AMENDMENTS TO THE DRAWINGS:

Appl. No. 09/876,290 Amdt. Dated December 7, 2004 Reply to Office Action of June 7, 2004

REMARKS

ASSEMBLY JIG AND MANUFACTURING METHOD OF MULTILAYER SEMICONDUCTOR DEVICE

FIG.1(a)

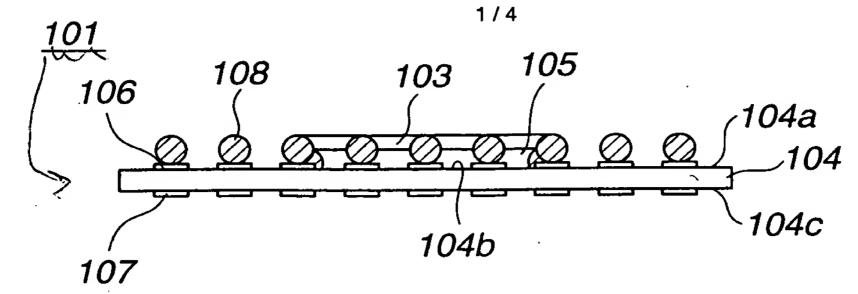
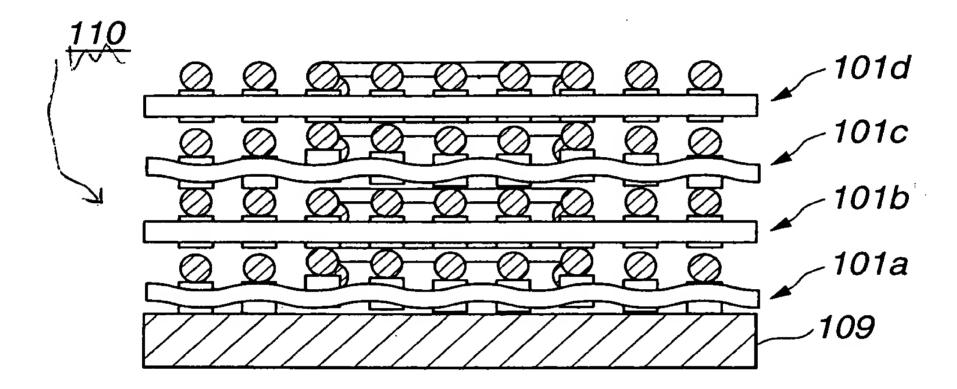
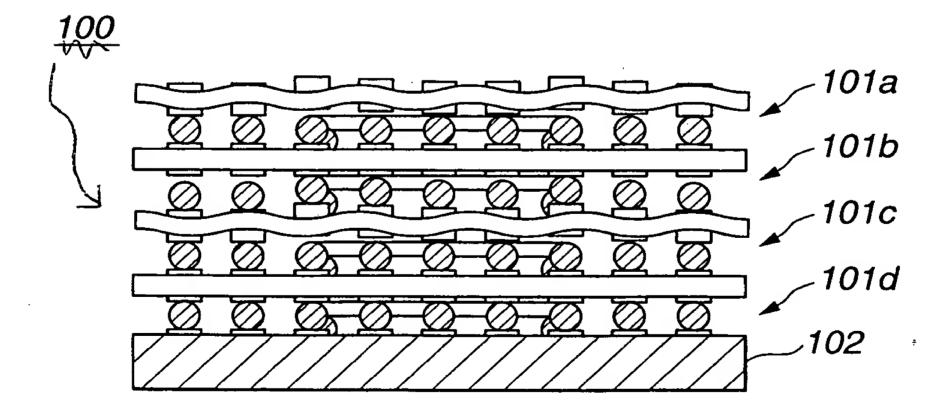
The sheet which includes Figs. 1(a)-1(c) replaces the original sheet including Figs. 1(a)-1(c). The lead lines requested by the Examiner have been added.

In regard to the objections to Figures 1(b) and (c) Applicants note that because the structure is flipped as described in the specification in the final paragraph on page three which states that the semiconductor module unit is reversed by the mounter. Accordingly, the Applicants submit that the illustrations of Figures 1(b) and 1(c) need not be changed and indeed accurately reflect the different board structures.

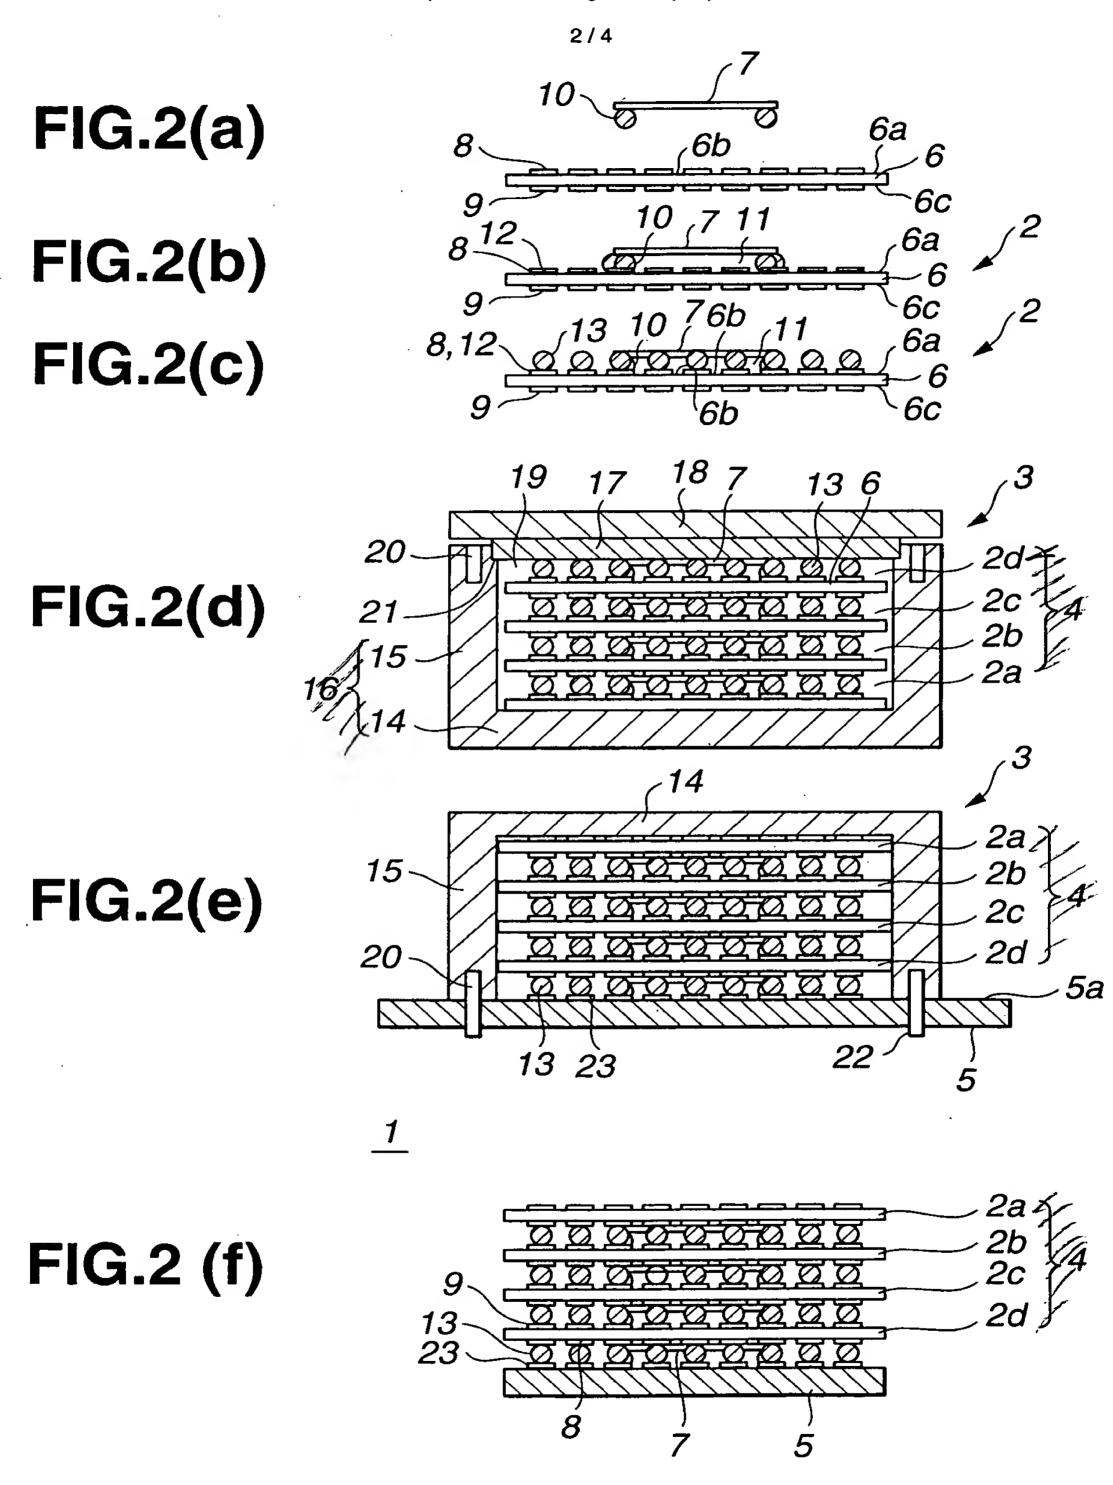
The sheet which includes Figs. 2(d)-2(f) replaces the original sheet including Figs. 2(d)-2(f). The brackets have been removed from the figures as requested by the Examiner.

Applicants submit that these changes and remarks overcome all of the drawing objections. In regard to the assertion that there is no box-shaped member positioned on a base, Applicants submit that Figure 2(e) as well as Figure 4 each clearly illustrate such a structure. The same is also true for the subject matter of claim 3, and that these elements are adequate described in the specification. Similarly, with regard to the Examiner's objections under 37 CFR section 1.83(a) of claims 6, 7, 12, and 13 as well as the rejections under section

112, first paragraph as to all claims Applicants submit that each of the referenced elements are clearly present in the specification. For example, the box-shaped element is reference 14 that is located on the base member 5. The height restriction mechanism is clearly illustrated in Figure 2(d) as element 17 which is also described in detail in the specification. All that the Examiner has done is make the bald unsupported allegation that all of the elements of the claims are not described in the specification and there is simply no foundation for these assertions and the rejections under section 112 should be withdrawn. Indeed, the specification actually uses the term "box-shaped" see page 15 in the second full paragraph. There is simply no foundation whatsoever for these rejections and objections and they should be withdrawn.

FIG.3

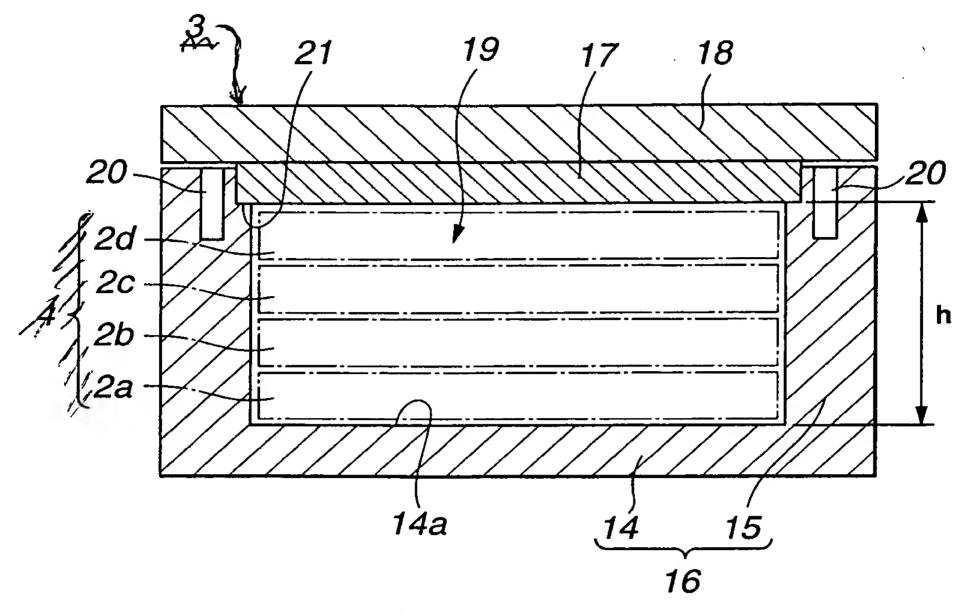
The sheet which includes Figs. 3 and 4 replaces the original sheet including Figs. 3 and 4. The bracket has been removed from Figure 3 and a lead line from reference designation 3 has been added as requested by the Examiner. In Figure 4 the bracket has been removed.

In regard to the Examiners objections to the drawings, Applicants have modified Figure 5(a) to include the height designation "h" and additionally applicants have modified the specification on page 20 in the second full paragraph to reflect the fact the height "h" reference is in Figure 5(a) and not Figure 5(b). Applicants have also eliminated the use of brackets as required by the Examiner. Additionally, Applicants have modified the drawings to include the requisite lead lines for Figure 3 as identified by the Examiner.

FIG.4

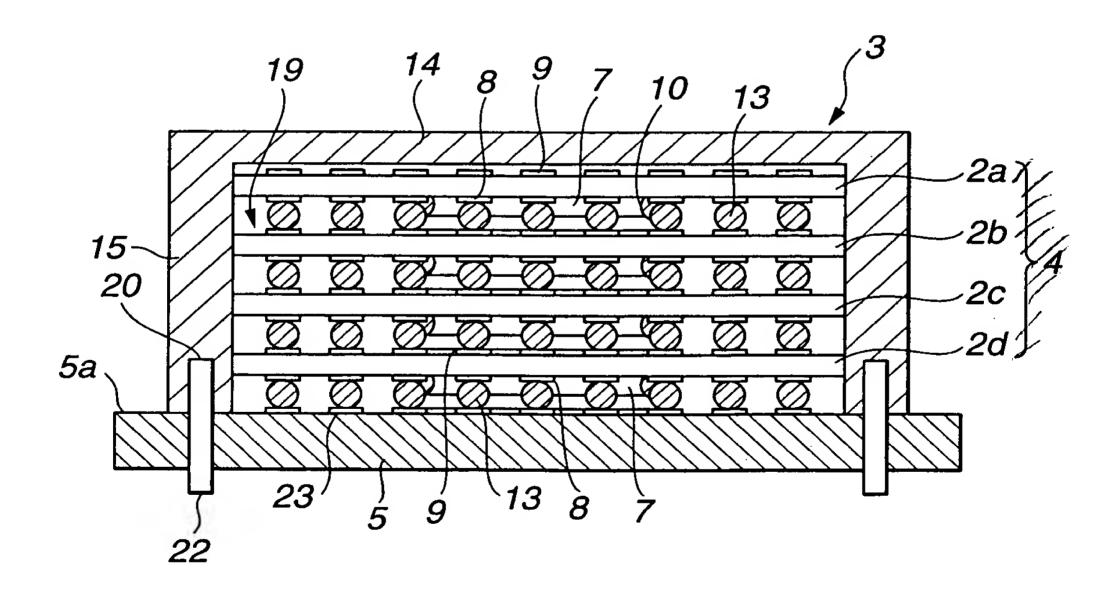
In regard to Figure 4, Applicants note that reference characters 3 and 19 are actually distinct elements. Reference 3 is directed to overall assembly jig and 19 is the layering space as noted in the specification. The reversing or flipping of the structure described above also obviates the Examiners issues raised on page 3 of the action with reference to the objections under 37 CFR section 1.84(p)(4). Accordingly these objections should be withdrawn as well. If the Examiner still believes that there is an outstanding unresolved issue then the undersigned requests that the Examiner conduct a telephone interview.

FIG.5(a)

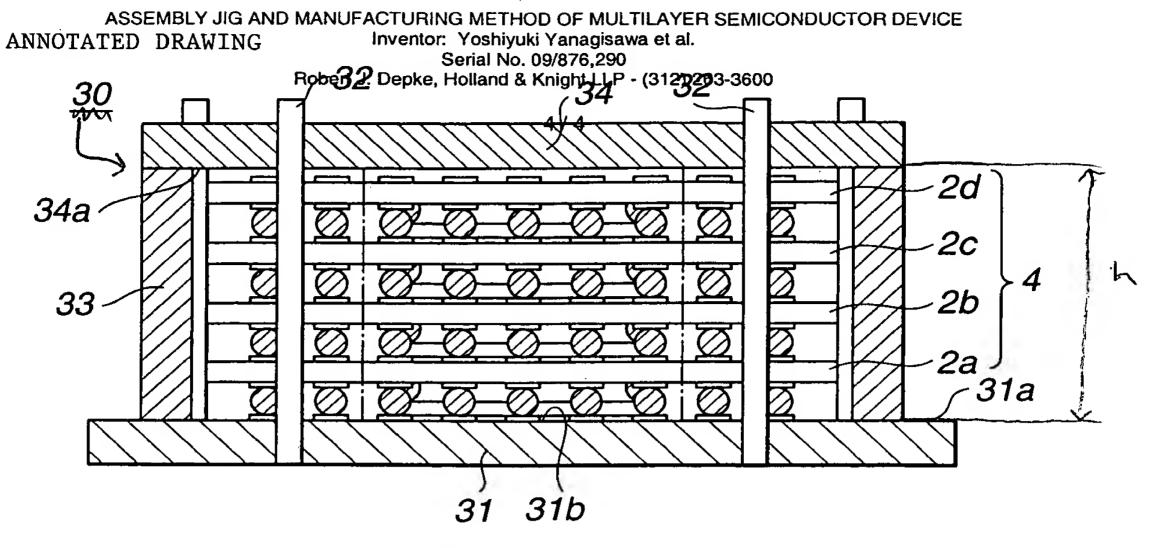
The sheet which includes Figs. 5(a) and 6 replaces the original sheet including Figs. 5(a) and 6. The height reference designation "h" has been added and a lead line from reference number 30 has also been added. In Figure 6 the bracket has been removed.
